**DEPARTMENT OF TRANSPORTATION****Research and Special Programs Administration****49 CFR Parts 171, 173 and 178**

[Docket No. HM-190; Amdt. Nos. 171-96, 173-206, 178-90]

**Modifications to DOT Specification 21 PF-1 Overpacks****AGENCY:** Research and Special Programs Administration (RSPA), Department of Transportation (DOT).**ACTION:** Final rule.

(b) Specification 21PF-1A and 21PF-1B (horizontal loading overpack).

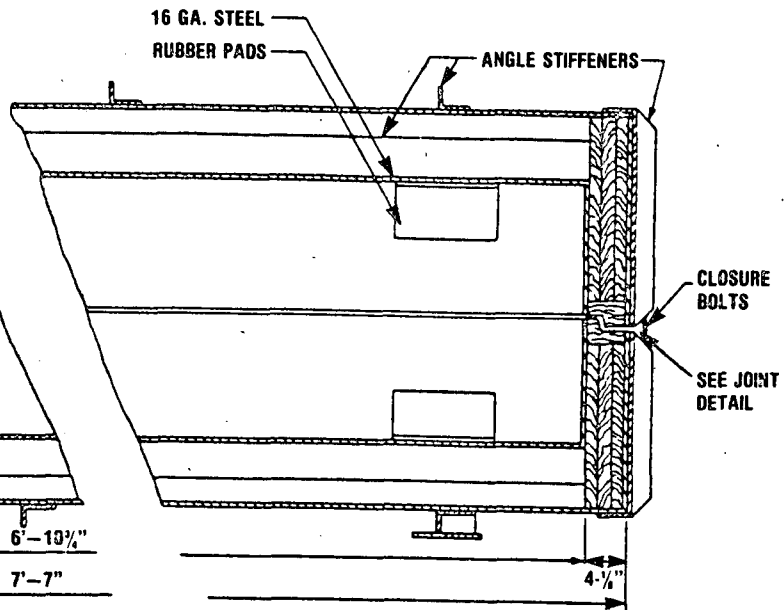
The first set of changes involves existing overpacks. The major changes are designed to remove (by drying) water which may be retained in the overpack, to drill drain holes in the external stiffener braces which tend to collect water, and to seal those joints which easily admit water. The sealing involves installation of a new joint cover and gasket, and application of a sealant compound to the stiffener joints and outer shell joints.

A carbon steel step-joint cover must be installed on the joint for the lower half of the overpack where experience indicates that water accumulation has been most significant. Step joint gaskets have been changed from a vinyl foam or expanded rubber to either a Silastic E RTV rubber or a silicon sponge. Inspection for wood warpage is required.

(a) Each Specification 21PF-1 overpack for which construction began or was completed before to April 1, 1989, in conformance with drawing E-S-31536-J, Revision 11, of CAPE-1662 must be modified in conformance with drawing S1E-31536-J1-D of CAPE-1662, Revision 1, Supplement 1, before April 1, 1991.

SECTION  
DOT SPECIFICATION 21PF-1B  
OVERPACK

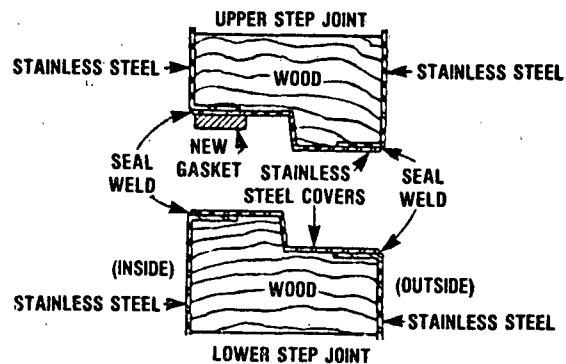
The second part of the amendment involves future construction of DOT 21PF-1 overpacks. These design changes are more comprehensive than those proposed for existing overpacks. The most significant of these changes involve (1) use of stainless steel instead of mild (carbon) steel for the metal shell, and (2) the step-joint at the overpack closure is reversed from a step-down to step-up joint. Continuous welds will assure the integrity of body seams and joints for the liner, shell, and step-joint. Welding requirements and welder qualifications are similar to those required for existing overpacks.

Wood materials are amended to include white oak as well as hard or sugar maple. All metal parts are changed from carbon steel to stainless

steel, thereby eliminating the need for painting the metal for weather resistance. The wood step-joint must be covered with stainless steel painted with a fire-retardant (intumescent) paint.
